Riley-Purgatory-Bluff Creek Watershed District
Board of Managers Regular Meeting
Wednesday, Aug 4, 2021 5:00pm Work Session Scheduled 7:00PM Regular Meeting
Virtual Meeting via ZOOM
<https://us02web.zoom.us/j/86253022544>

- a. Pulled consent items
- b. Accept June Treasurer's Report
- c. Approve paying of the bills
- d. Permit 2021-012 Noble Hill
 - 1. Accept Slope Stability Analysis for Noble Hill.

- 5. Permit 2021-017 Middle Riley Creek Stabilization Project
 - i. Consider approval of request for variance from Rule D, Subsection 3.2.b minimum and average buffer widths for permit application 2021-017 Middle Riley Creek Stabilization Project

Title: B2105970 - Noble Hill in Eden Prairie
Last Edited By: Rahman, Mohd
Date: 07/20/2021
Effective Stress Analysis

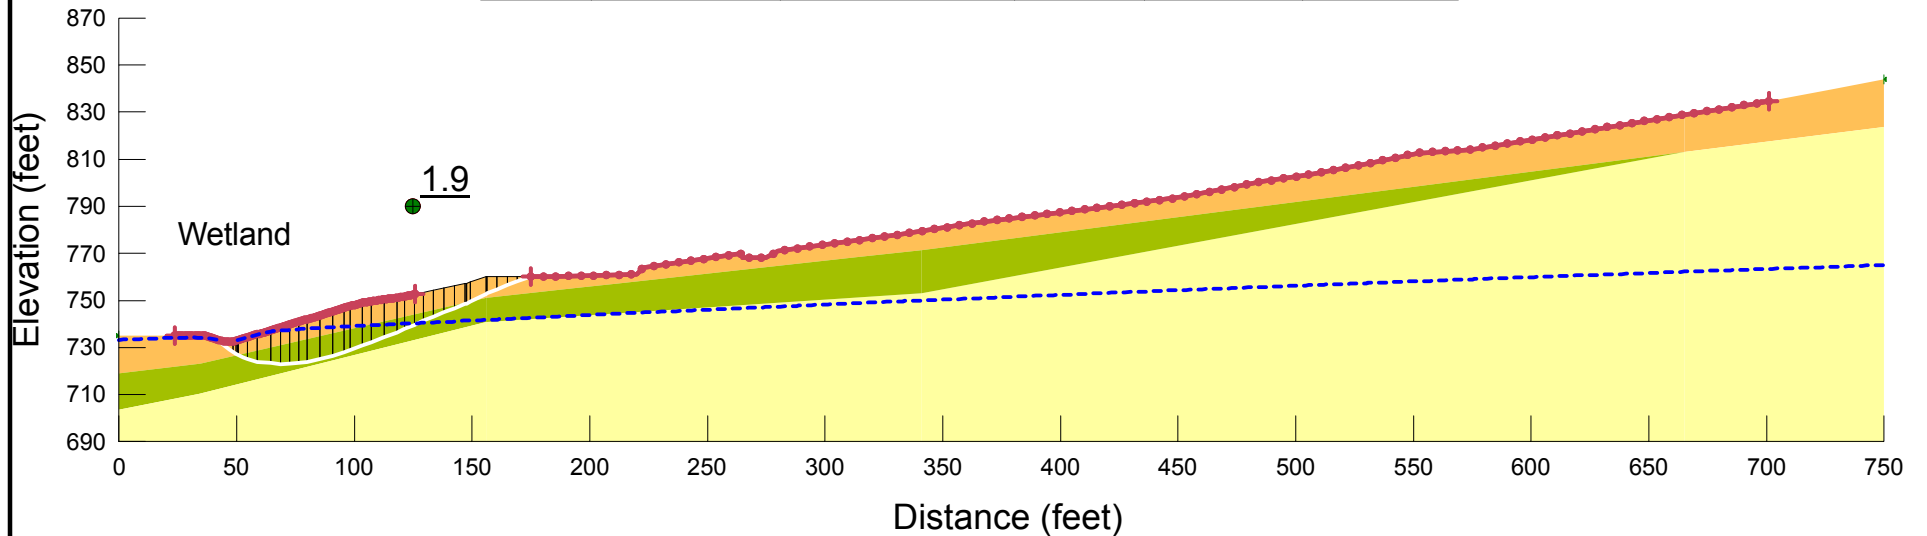
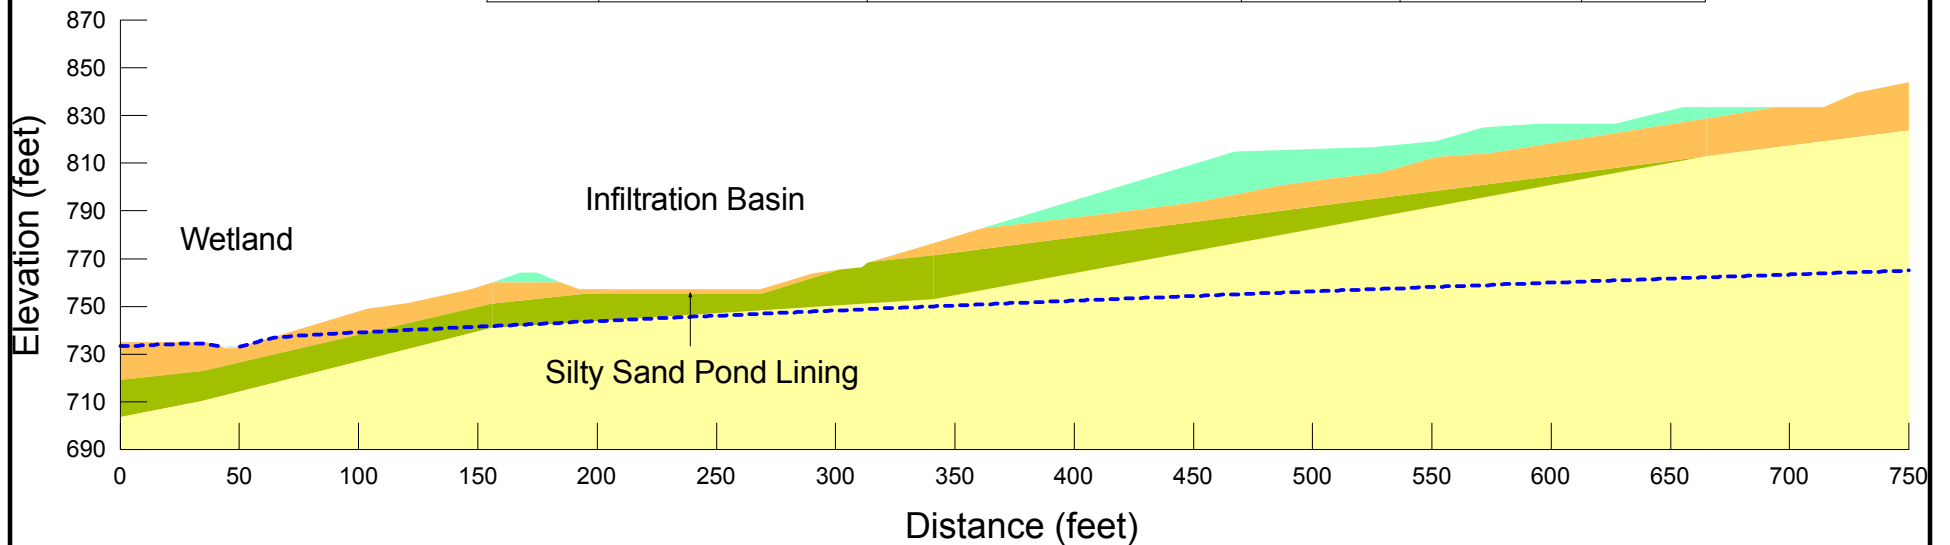
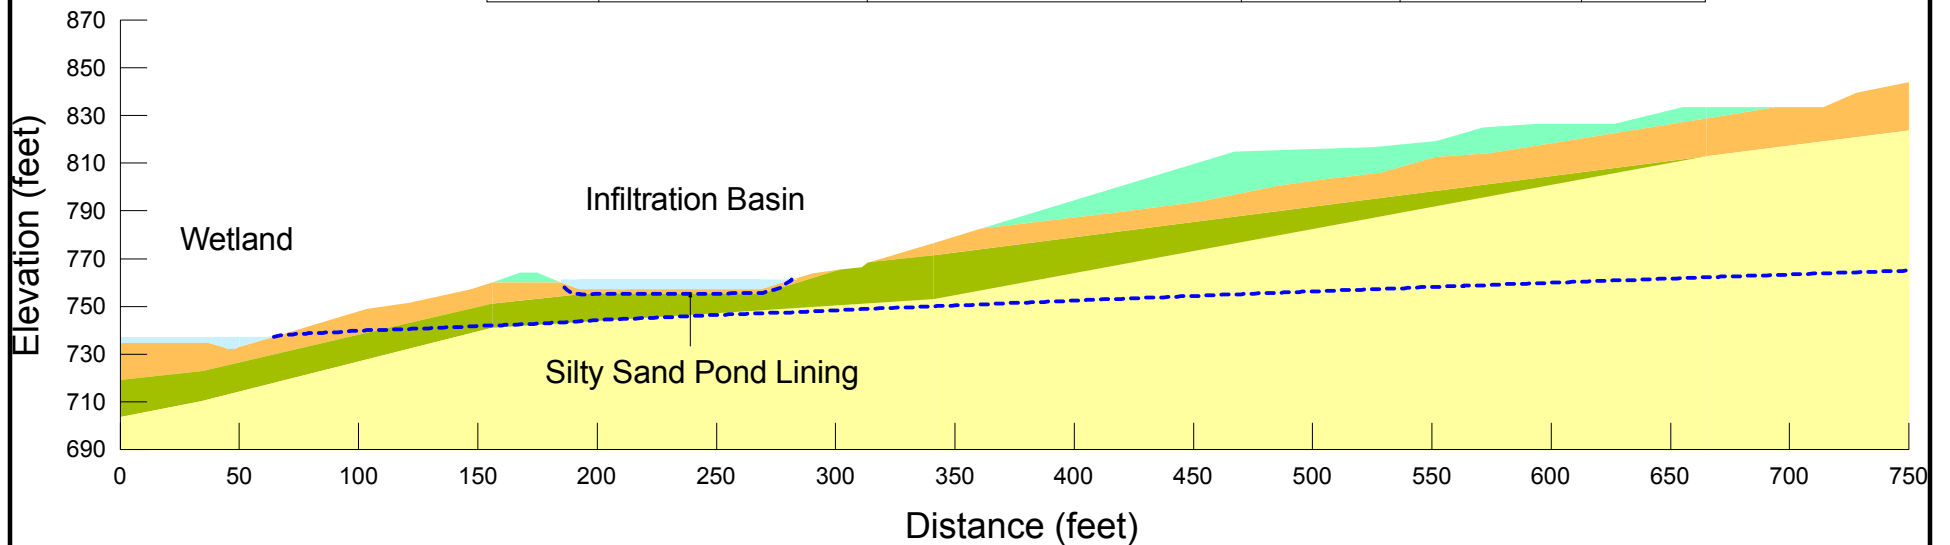
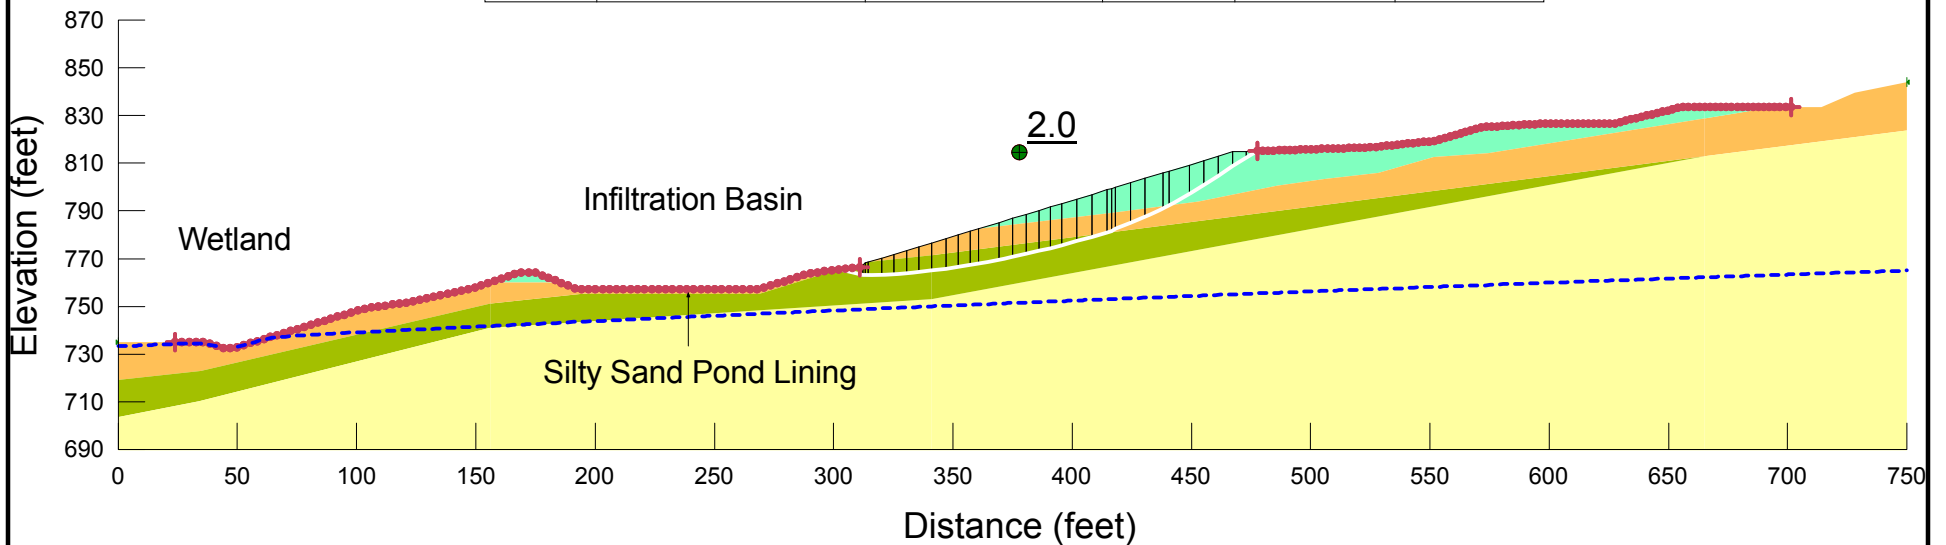
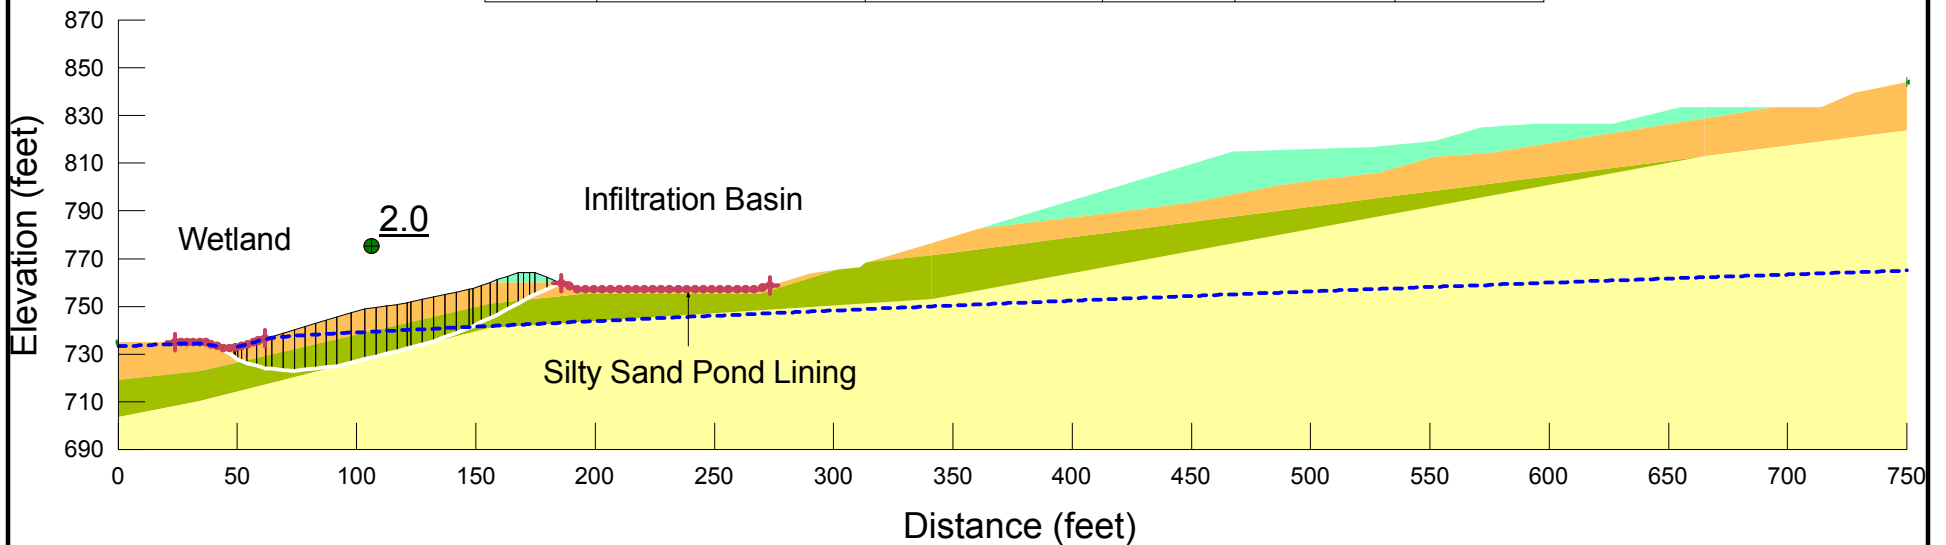
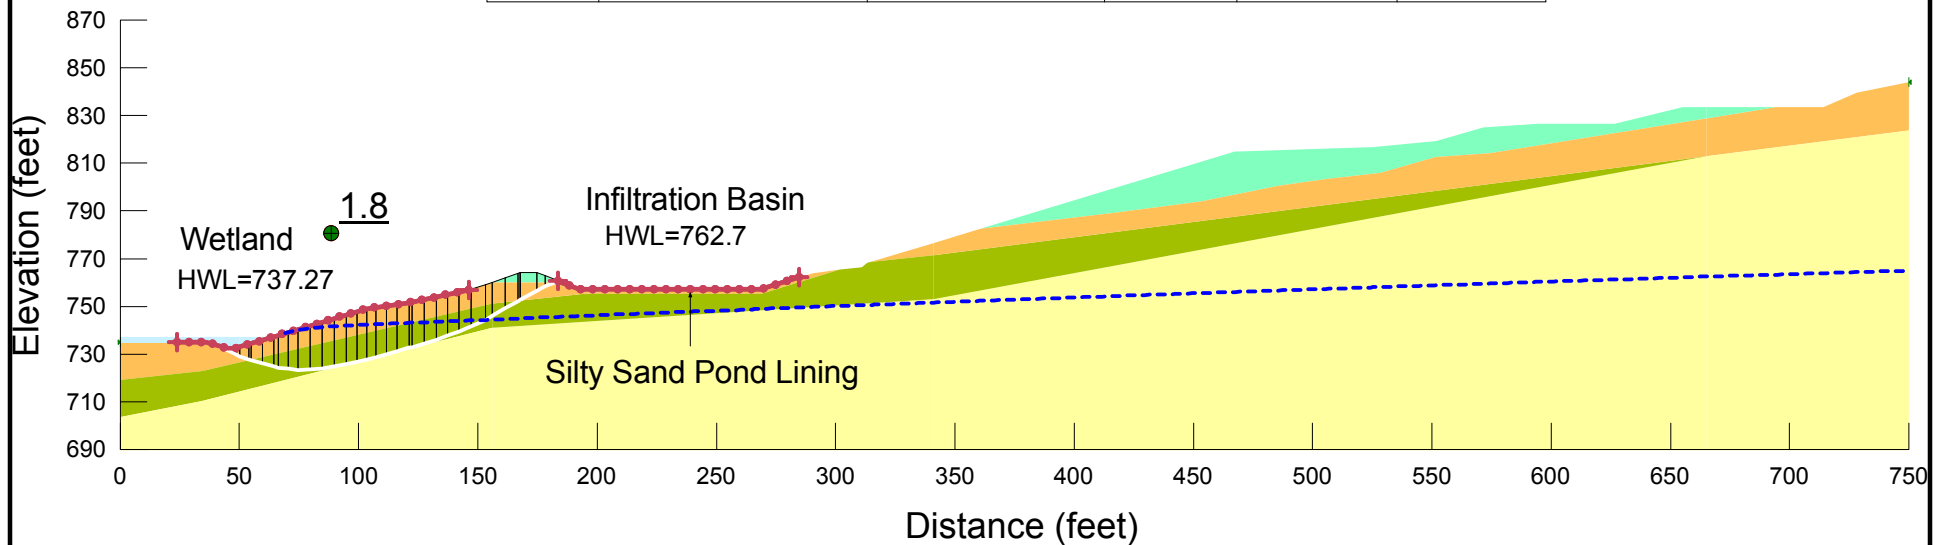
Based on the information reviewed and with the understanding that the above comments are being addressed, Barr's professional engineers and geologist reviewing the materials conclude:

- The slope stability factor of safety values are consistent with industry standards.
- Minor design revisions must be considered to minimize soil loss at the toe of slopes where modeling indicates potential seeps could develop downslope of infiltration basin 1 or at apron/outlets.

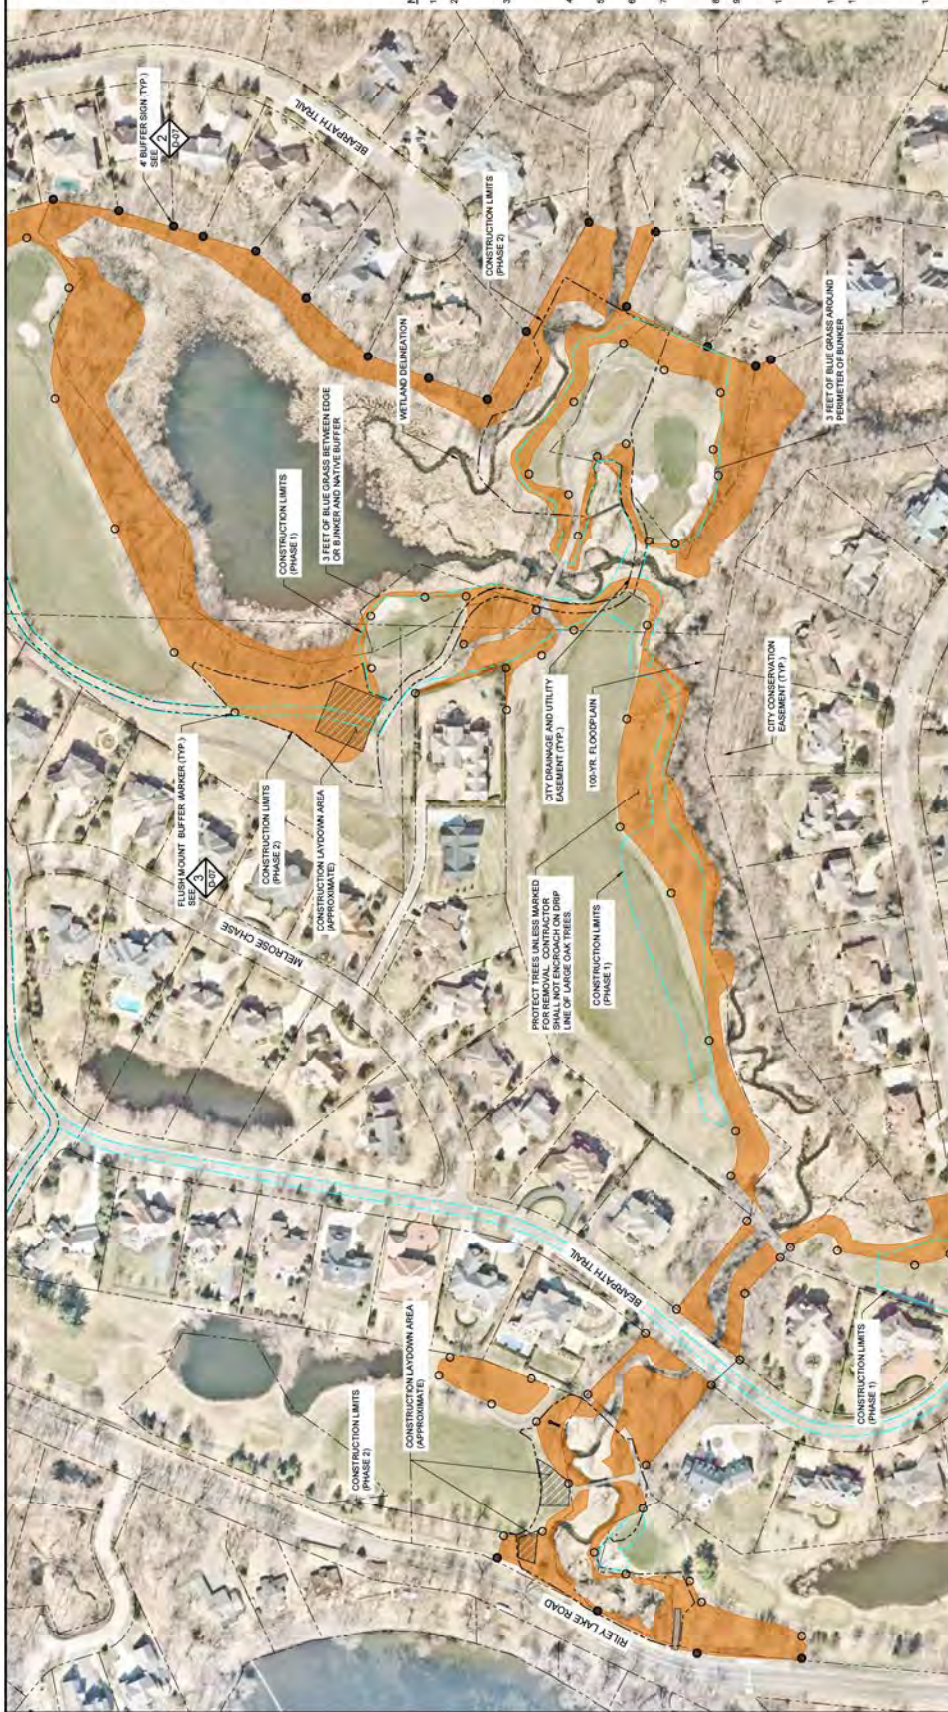
Buffer markers located at inflection points in the buffer's upland edge and along the edge of the buffer at intervals of 200 feet or less are required by Rule D, Subsection 3.4. As shown on Sheets C-04, C-05 and C-06 of the attached plans, the buffer markers will be located per Rule D criteria. Bearpath has requested a variance from the requirement for free-standing signs on private property to allow flush to the ground markers (See Rule K variance discussion). The RPBCWD and Bearpath are currently working on a cooperative agreement for long-term project maintenance, including maintenance of the buffer areas (subsection 3.5). Subsection 3.5 also requires the maintenance requirements of the buffer areas be recorded with Hennepin County. A note on sheet C-01 requires that the contractor conduct activities in a way that will minimize the potential for the transfer of AIS (subsection 3.6).
